CERL Technical Report 99/66
August 1999

Technical Assistance To Supplement Installation of Low NO_x Boilers at the Pentagon Heating and Refrigeration Plant

Figure 2. Windbox corrosion.

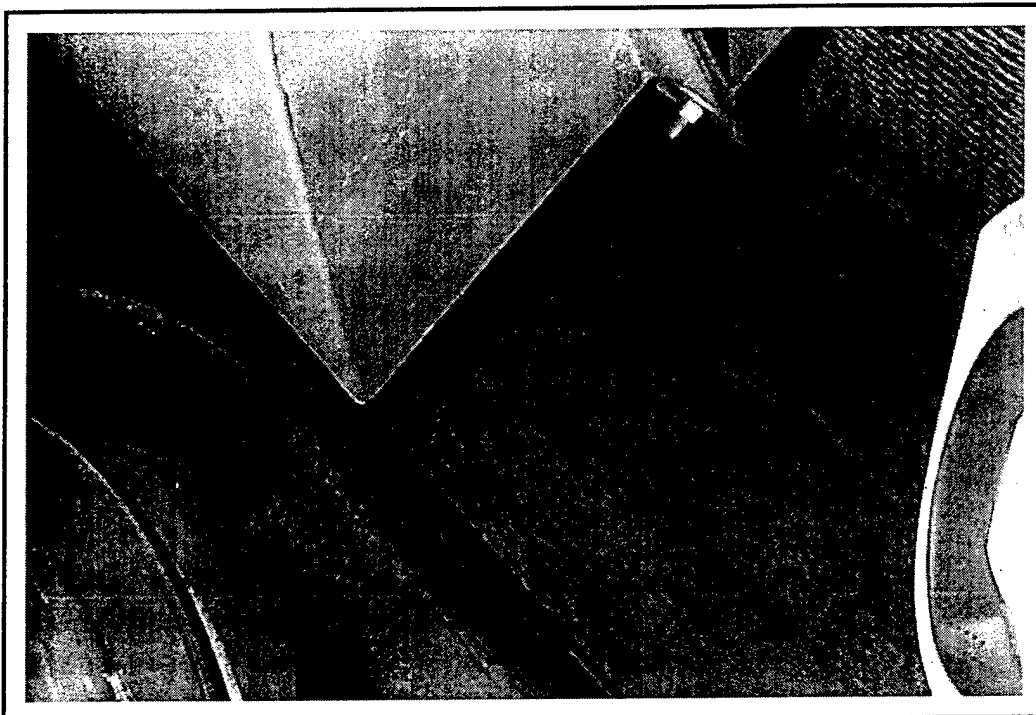
The installer opened up the windbox and furnace on Boiler #5. The windbox and burner are simple in construction. There are no vanes or baffles to ensure thorough mixing of the flue gas prior to entry to the burner throat. Corrosion had already begun to occur where the flue gas entered the windbox (Figure 2). The burner has one set of flat register vanes (Figure 3). The tubes in the windbox did not show any signs of flame impingement although boiler #5 did not have many hours of operation. The laydown chalk makings were still visible. The soot pattern from burning oil can be seen on the left furnace wall (Figure 4).

- Corrosion is already present in the windbox where the flue gas enters. The corrosion will shorten the life of the windbox equipment. Condensation of moisture in the windbox is not observed with induced flue gas recirculation burners. Although the boilers were specified to be able to burn #6 oil, such

Figure 9. DCS printout showing boiler No. 4 trends.

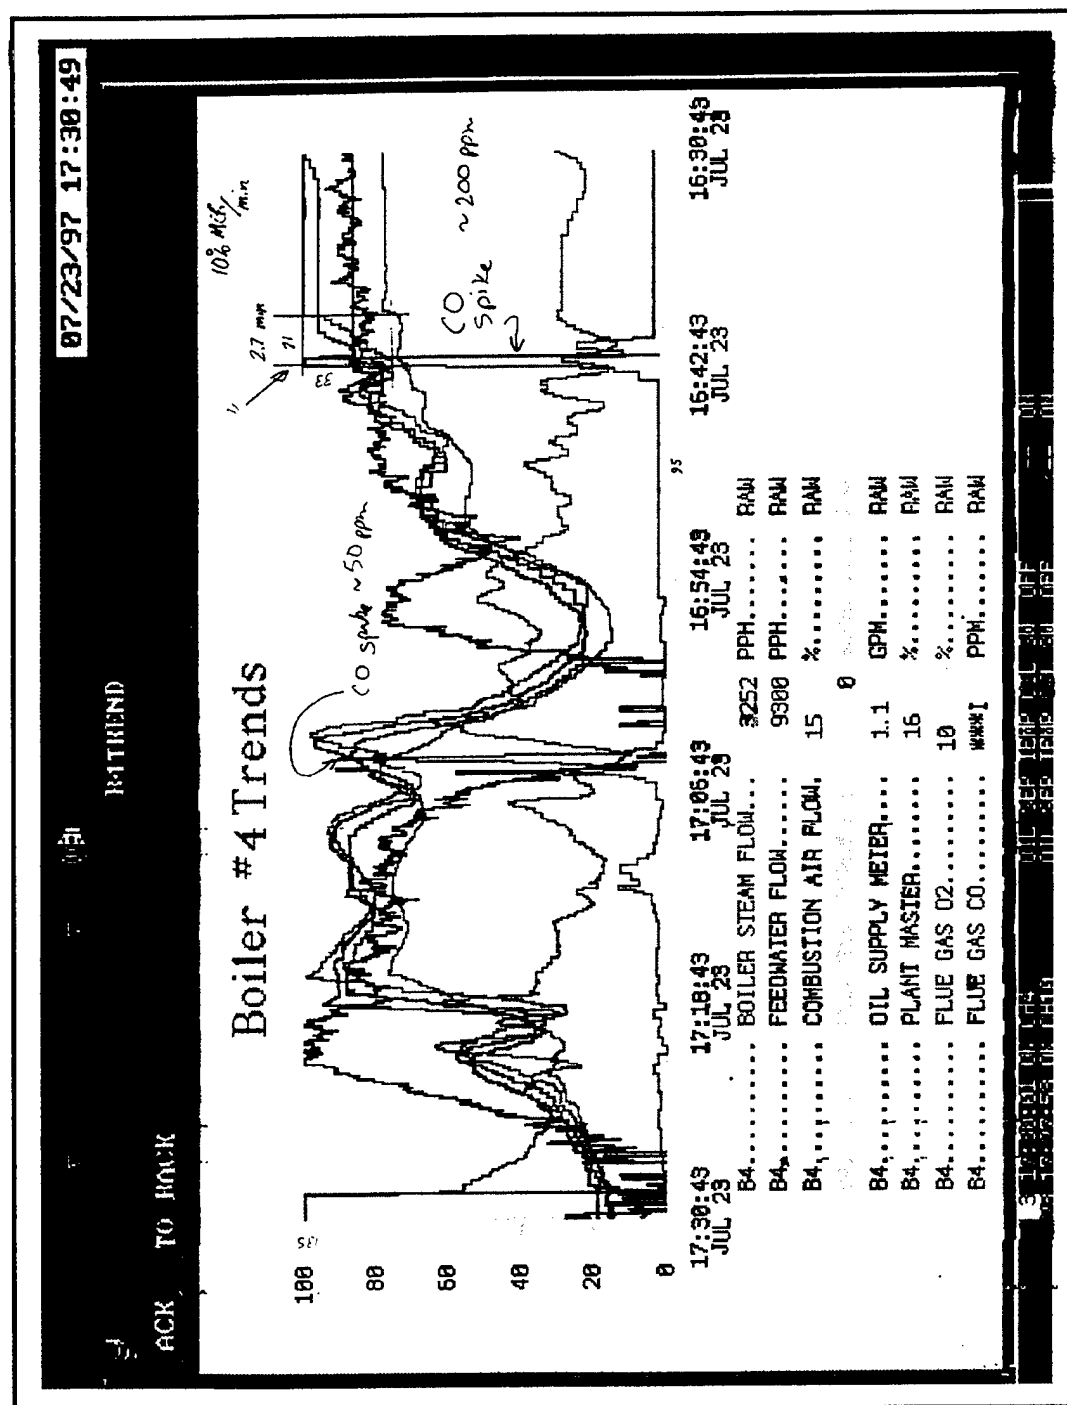
The PRO letter also states that "unexpected carbon monoxide excursions were witnessed 7-9 May 1997 which were possibly due to DCS communications failure." When operating above the turndown limit of 6 to 1, the burners performed satisfactorily. On 23 July 1997, when changing the steam load manually at very high rates (greater than 10 percent Max Continuous Rating [MCR] per minute), there were two CO excursions above 50 PPM when near full load followed by dropping load quickly. (Figure 9 shows the DCS printout.) It was not clear to the team why the excursions occurred under these abnormal operating conditions. Although the load change was abnormal, a parallel metered control system should have been able to handle that change. The control system did respond to the excursion appropriately and increased air to quickly reduce the CO levels. The fuel train may need closer examination to precisely identify the cause of the CO excursion. The control system characteristic curve may need adjustment. For an unknown reason at 16:40 on 23 July, the controls let the fuel valve remain fully open for 30 to 60 seconds after the airflow was being reduced. It appears that the control system ruled that the airflow was so excessive that the fuel did not need to be reduced until the airflow signal had dropped significantly. One factor may be that the fuel oil supply pressure was increased slightly to try to reach full load. The burner did perform safely under normal load transients. However, if the current airflow-metering scheme is used, the team has recommended that the control system characteristic curve be inspected and recalculated.

Figure 10. ASME Code B31.1, Fig 100.1.2(B).

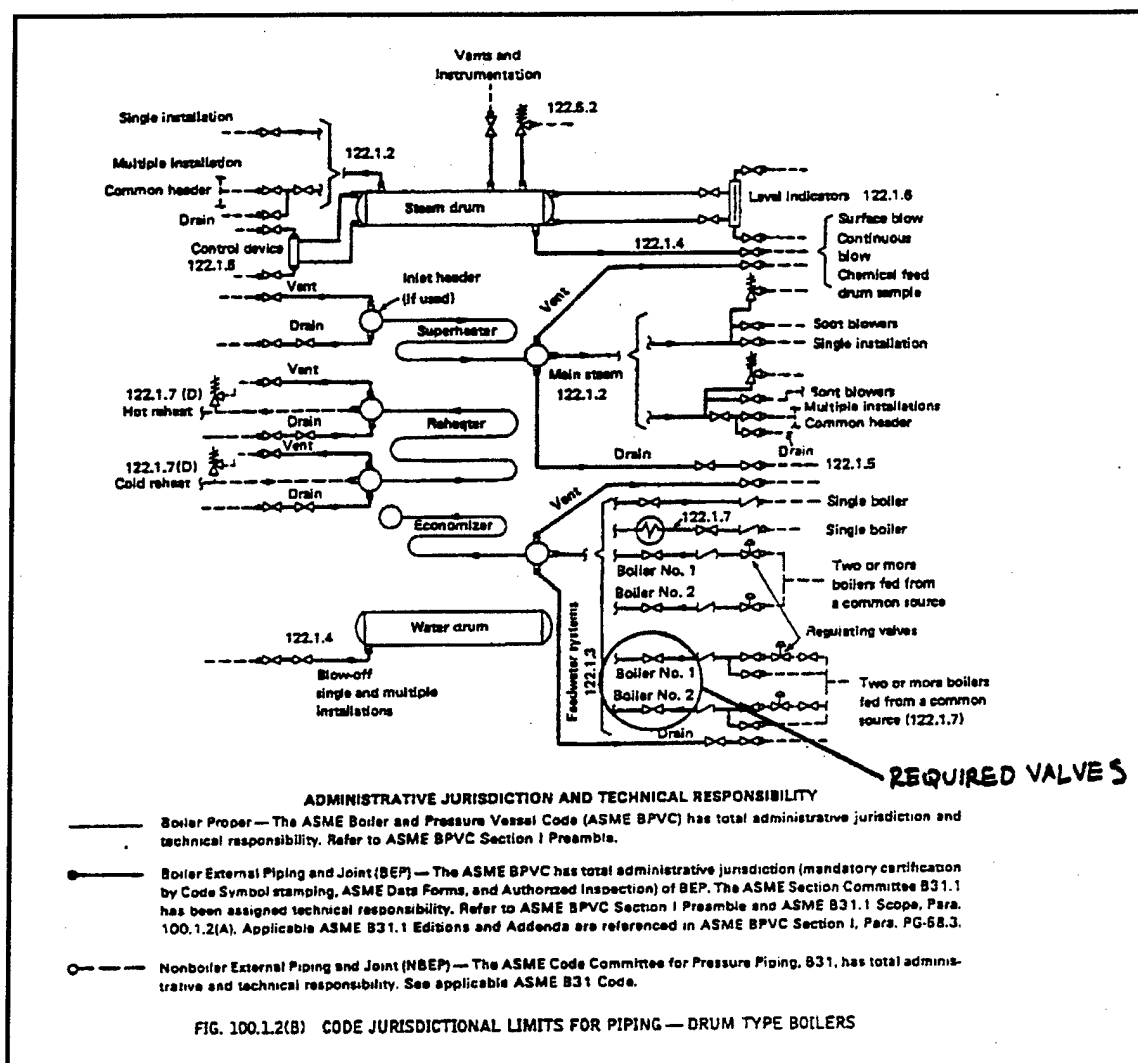
- An ASME Boiler and Pressure Vessel required valve is missing in the feedwater piping. Figure 10 shows ASME Code B31.1, Fig 100.1.2(B). There should be a stop valve isolation valve between the check valve downstream of the feedwater regulation station check valve and the economizer.

Figure 12. Windbox corrosion November 1998.

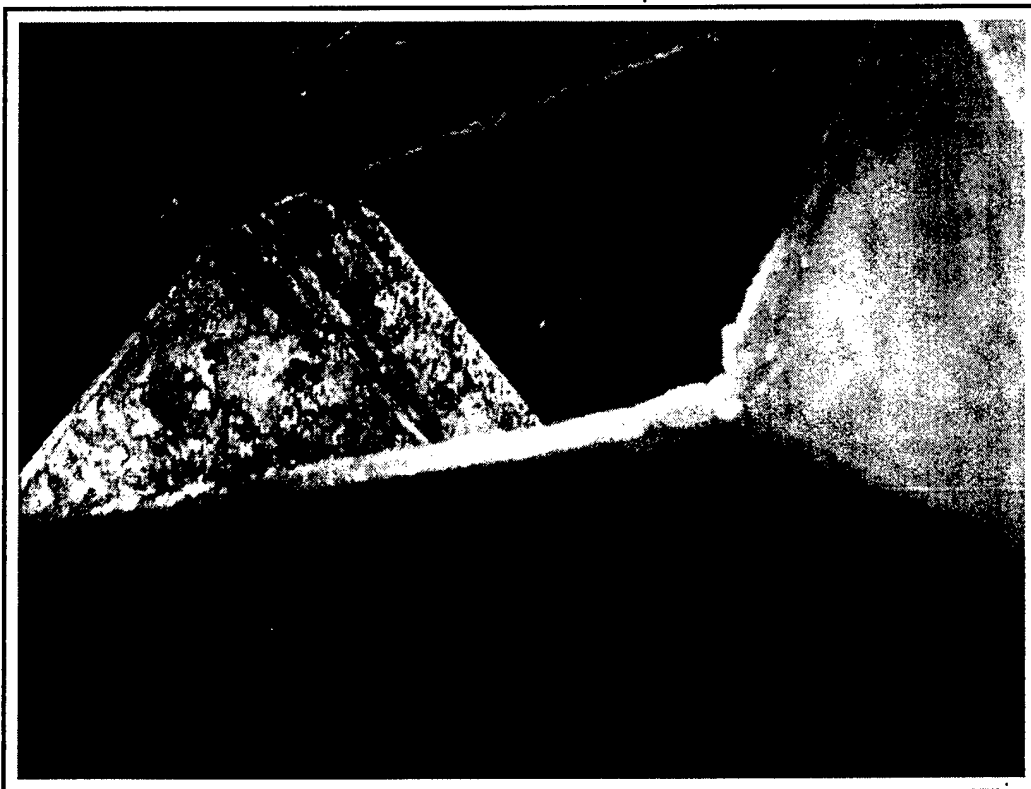
The team was tasked to provide a suggestion or opinion on options to eliminate or minimize the cause of the degradation of the opposed blade dampers inside the windbox controlling the recirculated flue gas flow. PHRP reported that the dampers were severely corroded. The manufacturer of the windbox has offered

The team inspected the windbox and concurred with PHRP that unacceptable amounts of moisture were being deposited where the flue gas enters the windbox (Figure 12). The moisture has and will continue to cause excessive corrosion on the recirculated flue gas dampers, gas line in the windbox, and the gas ring. The corrosion will greatly shorten the life the burner. The team can investigate the life expectancy of the burner ring. Vincent Hock at CERL can provide corrosion expertise support. The team can also provide a list of burner manufacturers who have successfully installed low NOx burners at DOD sites if desired.
